<b>Device</b>	<b>XMC1100</b>
<b>Marking/Step</b>	<b>EES-AA, ES-AA, AA</b>
<b>Package</b>	<b>PG-TSSOP-16/38, PG-VQFN-24/40</b>

## Overview

This “Errata Sheet” describes product deviations with respect to the user documentation listed below.

**CCU AI.005 CCU4 and CCU8 External IP clock Usage**

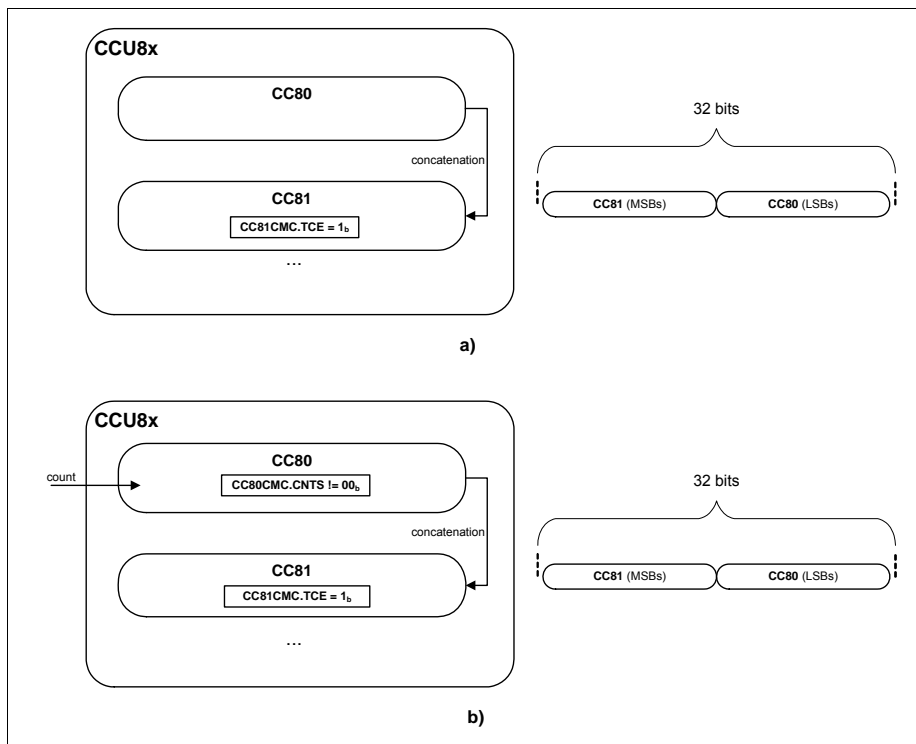
Each CCU4/CCU8 module offers the possibility of selecting an external signal to be used as the master clock for every timer inside the module Figure 1. External signal in this context is understood as a signal connected to other module/IP or connected to the device ports.

The user has the possibility after selecting what is the clock for the module (external signal or the clock provided by the system), to also select if this clock needs to be divided. The division ratios start from 1 (no frequency division) up to 32768 (where the selected timer uses a frequency of the selected clock divided by 32768).

This division is selected by the PSIV field inside of the CC4yPSC/CC8yPSC register. Notice that each Timer Slice (CC4y/CC8y) have a specific PSIV field, which means that each timer can operate in a different frequency.

Currently is only possible to use an external signal as Timer Clock when a division ratio of 2 or higher is selected. When no division is selected (divided by 1), the external signal cannot be used.

The user must program the PSIV field of each Timer Slice with a value different from 0000<sub>B</sub> - minimum division value is /2.

This is only applicable if the Module Clock provided by the system (the normal default configuration and use case scenario) is not being used. In the case that the normal clock configured and programmed at system level is being used, there is not any type of constraints.

**Figure 2 Baud Rate configuration sequence during ASC BSL entry**

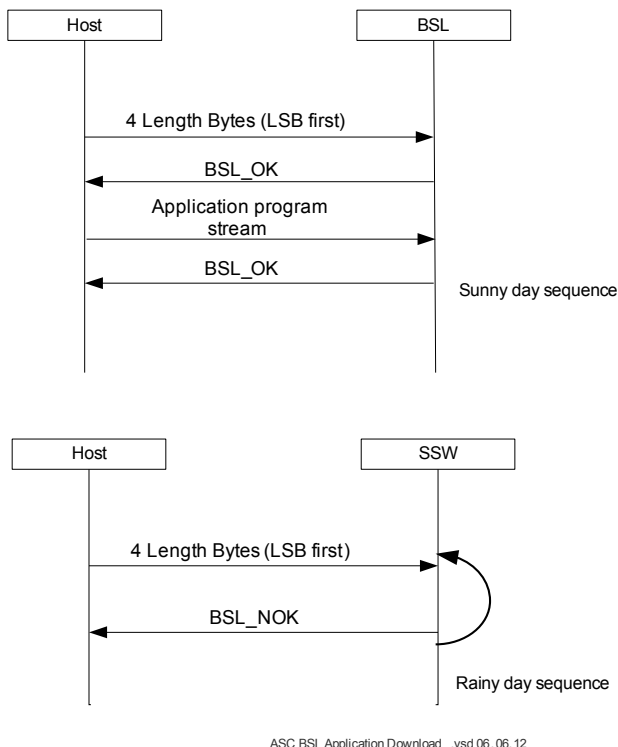
### **Firmware CM.H001** Switching to high baudrates in enhanced ASC BSL

The ASC Bootstrap Loader allows the user to switch to baudrates higher than the initial baudrate when the communication is established for faster downloading of code/data.

With the current implementation (refer to the “Bootstrap Loaders and User Routines” chapter in Reference Manual) the host device (e.g. a PC) may have problem to switch the baudrate fast enough after sending the request (BSL\_STEP as of [Figure 2](#)) and is not able to receive the device acknowledge (BSL\_BR\_OK) correctly with the changed ASC channel speed. If this happens, the host will get some error condition - wrong response, start bit not detected, etc. In such a case the host has to ignore the error and send the trailer Byte (BSL\_BR\_OK) with the new baudrate. The correctness of the communication speed settings will be then decided by the host upon the response from the device after sending the length of code for downloading (refer to [Figure 3](#)).
